File ID: 2018-2784

Application of Sid Tepaul to rezone property from R-100 (Residential Medium Lot-100) to RSM (Residential Small Lot Mix) to allow development of a 33-lot urban single-family detached subdivision, at 4601 & 4625 Flat Shoals Road. (Amended to R-75 (Single-Family Residential District and 13 single family detached homes on 10/12/18).

Petition No.: Z-18-1235209

STAFF ANALYSIS

Concept Elevation

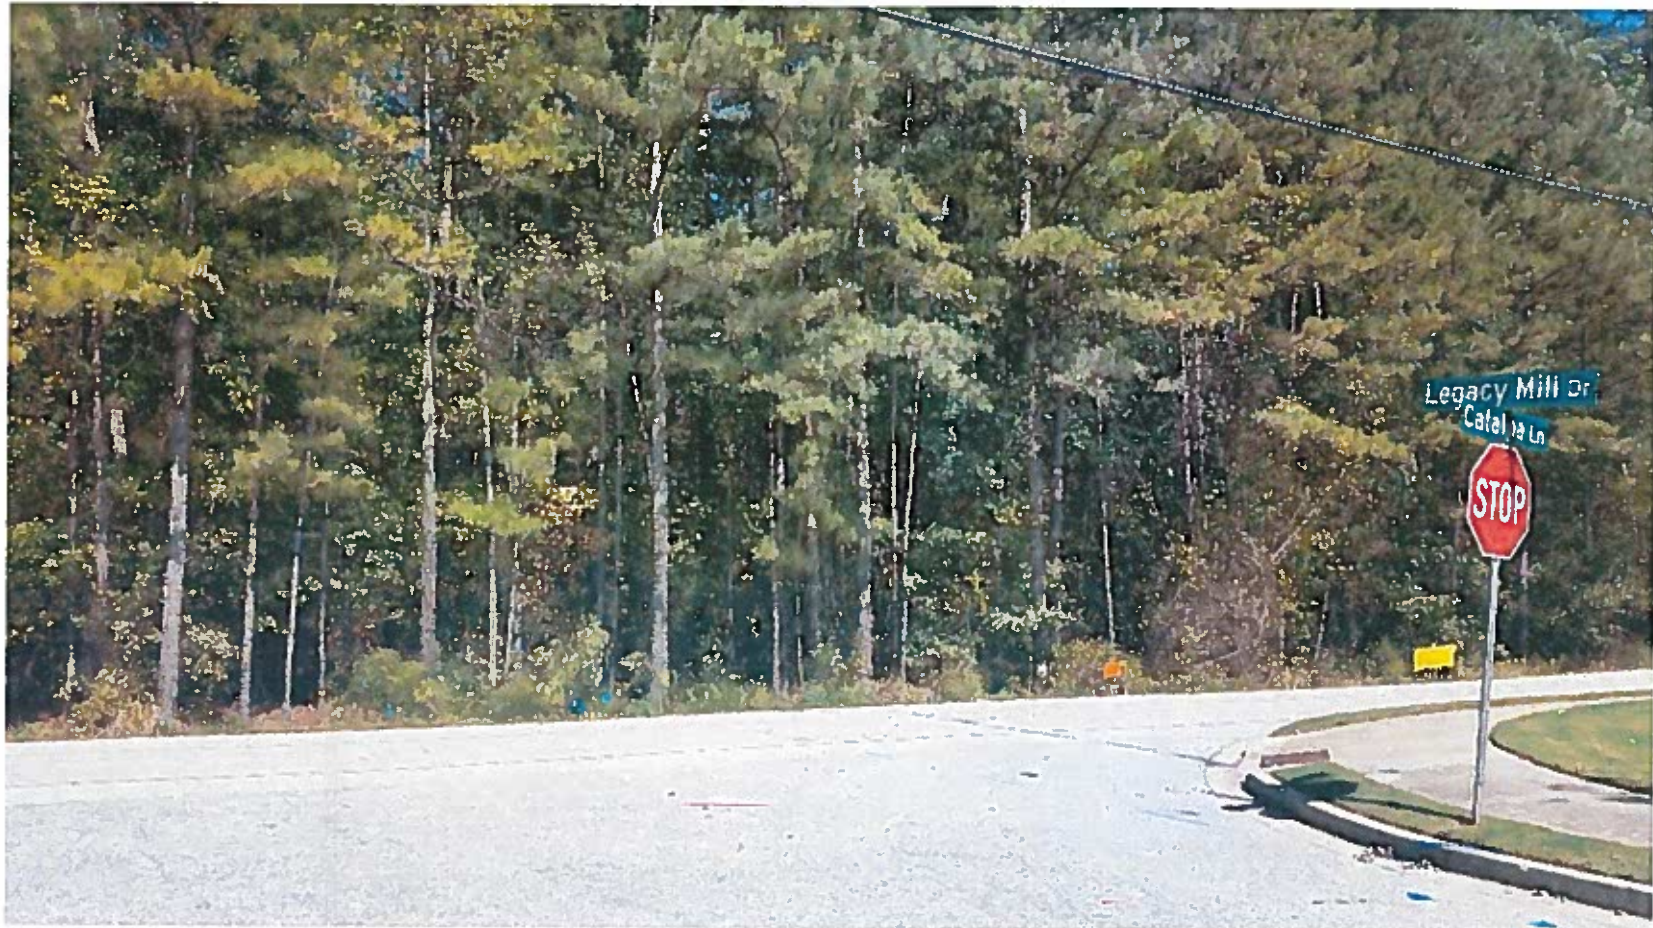
COMMUNITY COUNCIL VOTE/RECOMMENDATION: OTHER 0-5-1. No quorum. Five of the six CC3 Board members present agreed that the application should be denied. One of the Board members abstained. Comments included: the proposed buildings, because of the compact layout, look like "fire traps"; the layout with front porches looking onto a common green space looks like "the projects"; there is not enough information about the appearance of the homes; the houses are too close together and aren't consistent with the development pattern of the surrounding area.

9. All proposed homes shall include a front porch and a rear screened patio with dimensions subject to the provisions of Article 5 of the Zoning Ordinance.
